# Manual Supplement

Manual Title: 1760 Users  
Print Date: June 2006  
Revision/Date: 2, 5/10

Supplement Issue: 1  
Issue Date: 2/11  
Page Count: 1

## Change #1, 57261, 57516

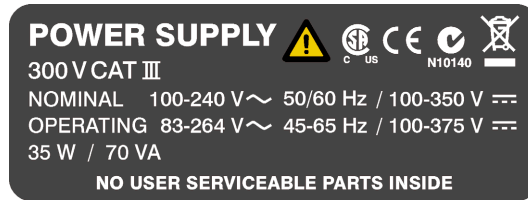
On page 1-7, replace the first Figure with the following:
